UNITED STATES PATENT AND TRADEMARK OFFICE

APPLICATION NO.	FILING DATE	FIRST NAMED INVENTOR	ATTORNEY DOCKET NO.	CONFIRMATION NO.
10/538,913	09/29/2005	Andrea Venturelli	5659	5133

Office Action Summary	Application No. 10/538,913	Applicant(s) VENTURELLI, ANDREA	
	Examiner Timothy J. Neal	Art Unit 3731

DETAILED ACTION

FIG. 2

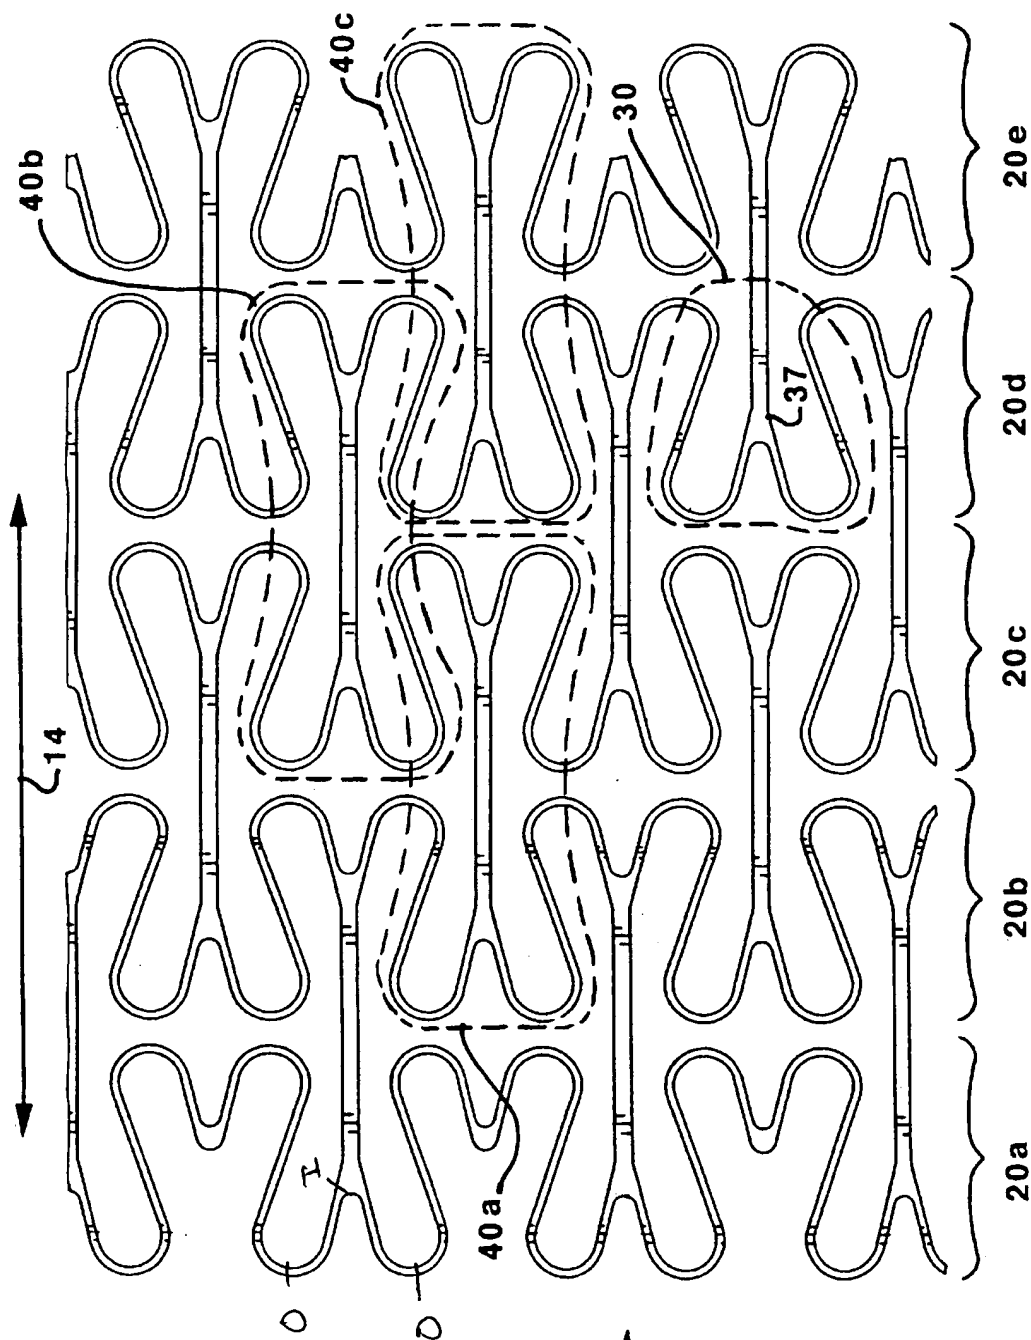
The Examiner is including a sheet to more clearly show the outer and inner lobes. The outer lobe is not directly connected to the bridge. However, it is indirectly connected via the inner lobe. This is clearer on the additional sheet. The distance between the outer lobe apex and the inner lobe apex is less than the distance between the two outer lobe apexes. The Examiner also considers the lobes to open alternately on opposite sides of the pathway of the padder. Figures 32 and 33 of the Applicant's drawings are essentially the same as Dang's figure 2. The only difference is that the

bridge directly connects two outer lobes. All other claims are dependent from claim 1 and no further arguments were made regarding these claims.

O=outer
I=inner
